S E R V I C E N O T E

SUPERSEDES: 4396A-01B

4396A Network/Spectrum Analyzer

Firmware Update and A1 CPU Repair Information

Figure 1. Bootloader Screen

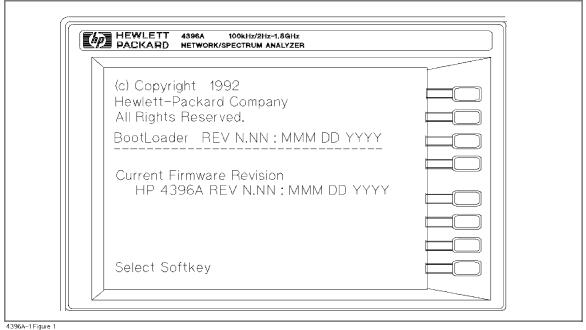
- 1. Turn the unit power off.
- 2. With pressing both the "Start" and "Preset" keys, turn the unit power on.
- 3. Check if the Bootloader screen shown in Figure 1 appears on the CRT.

When the Bootloader screen appears:

The A1 CPU is flash memory version. Update the firmware using the firmware installation kit w/o flash memory (pn 04396-65210). It is installable by customers.

When the normal measurement screen appears:

The A1 CPU is ROM version. Using the firmware installation kit w/ flash memory (pn 04396-65211), replace the ROMs with the flash memories on the A1 CPU, then update the firmware using the firmware disk. It is not installable by customers.
